Product Change Notice (PCN)

PCN Number: PCN-0374346R-01

Product(s) Affected: *CST-931AP*

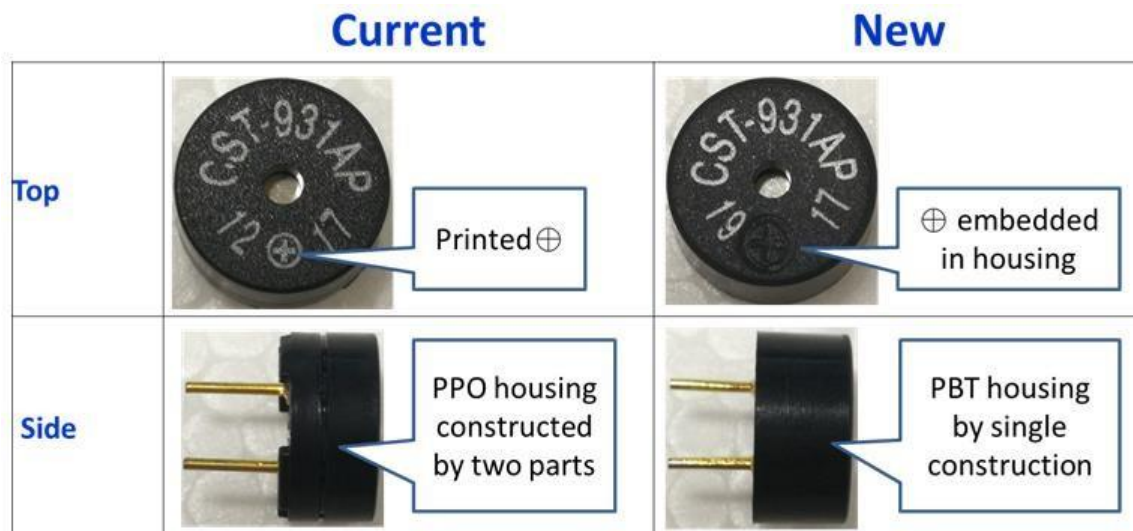
Description of Change: *Housing changing from two pieces (top+bottom) to one single plastic piece, plastic changing to higher temperature PBT material, positive terminal marking embedded into housing instead of printed.*

Reason(s) for Change: *To ensure product housing stays uniform and offer a higher temperature rating.*
